STAFF RECOMMENDATION

1504 Ordway Place

July 20, 2016

Application: New construction--addition

Figures 2 & 3. The red arrow shows approximately where a new window will be installed and the yellow areas show the windows to be relocated.

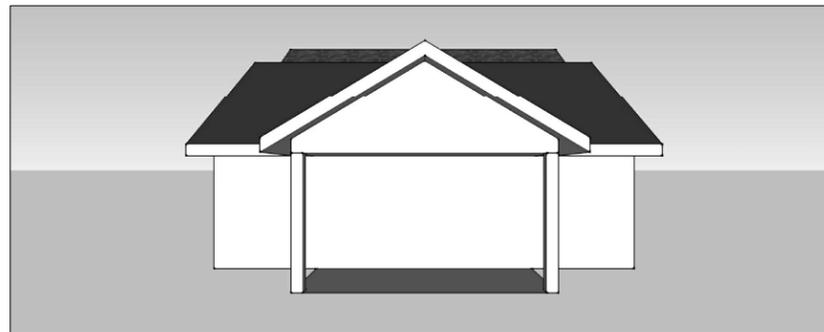
Partial Demolition: The applicant is to proposing to install a new window on the right elevation (Figure 2). The applicant also wants to relocate two windows on the rear portions of the side facades (Figures 2 &3).

Staff finds the insertion of a new window opening on the right façade to be appropriate in this instance because it is uncommon for an historic house to have such a long expanse of wall space without a window or door opening. The new window opening will be in keeping with common window patterns for historic houses of this date and form. In addition, the new window opening is necessary in order for this portion of the house to be used as a bedroom. Staff also finds the relocation of the window openings on the rear portions of the side facades to be appropriate because these windows are located over thirty feet (30') from the front wall of the house. Although they are visible from the street, their alteration and relocation will not significantly impact the historic character of the house.

Staff therefore finds that the partial demolition of the side walls for the new window openings meet Section IV.B.2 for appropriate demolition and does not meet Section IV.B.1 for inappropriate demolition.

01 RIGHT ELEVATION (WEST)

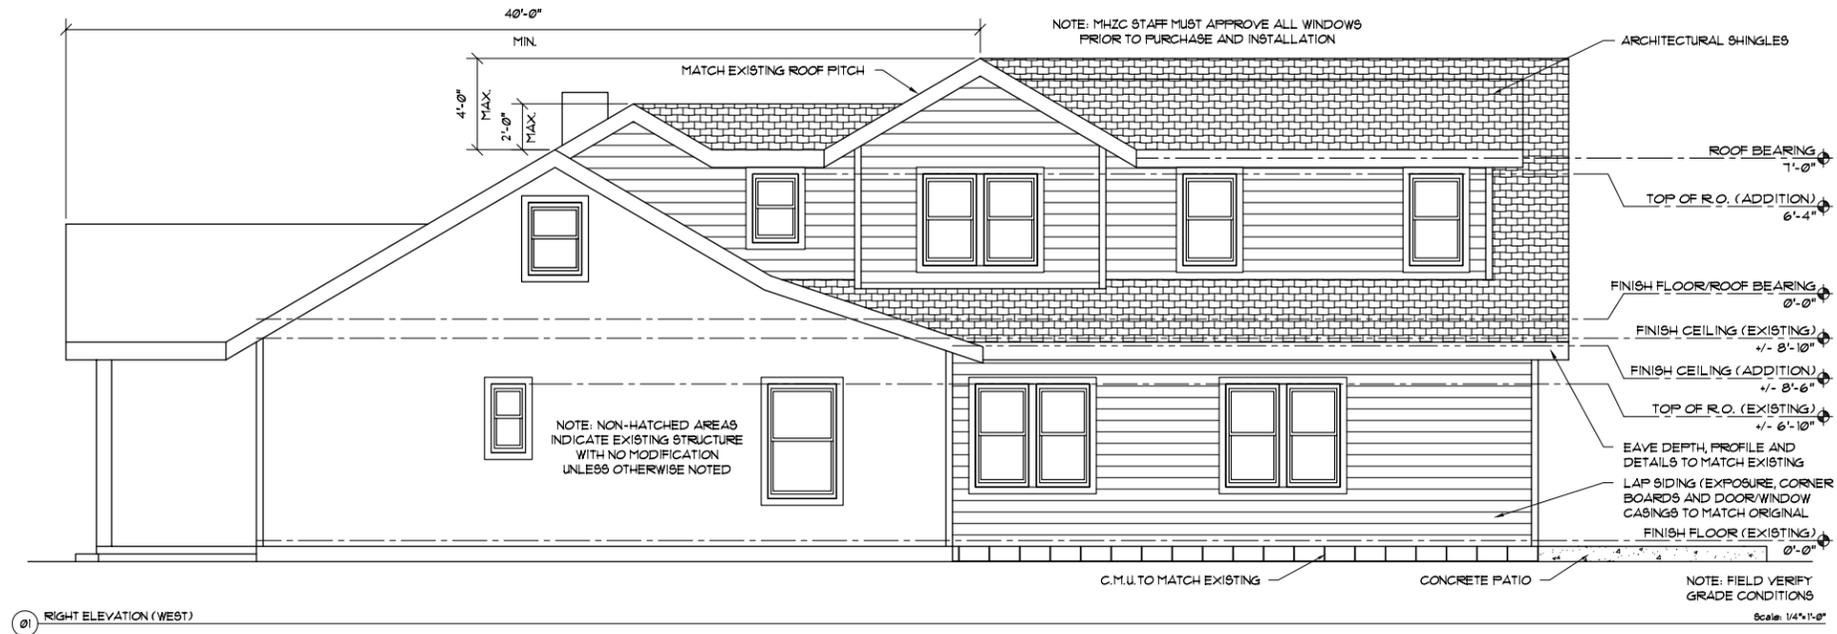
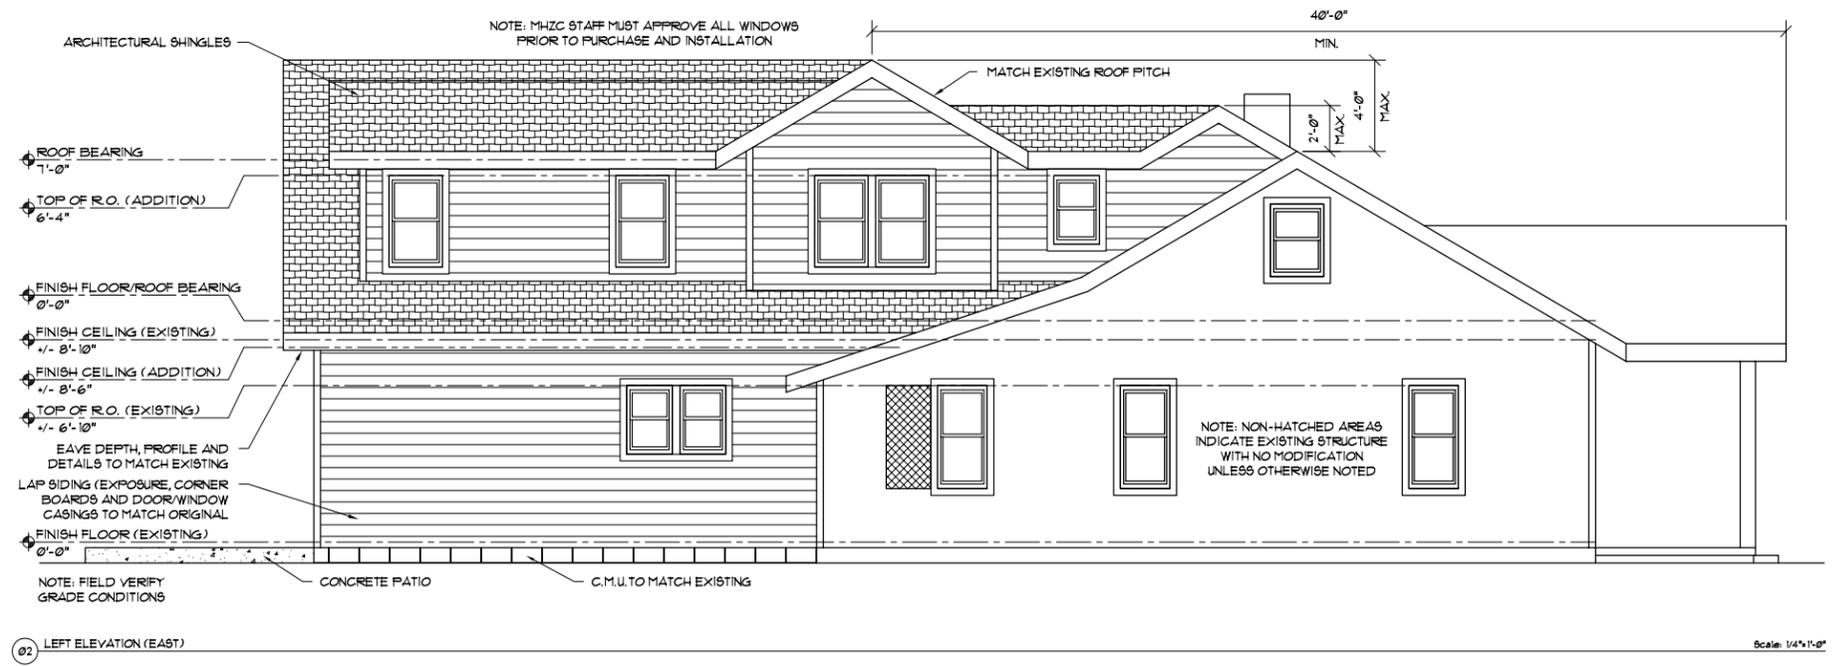
Proposed Project	Appropriate?
Alterations to windows on existing house	Yes – described under “Partial Demolition”	Yes
Windows twice as tall as they are wide?	Yes	Yes
Largest Section of Wall Without a Window/Door Opening	13’	Yes – At rear of left elevation
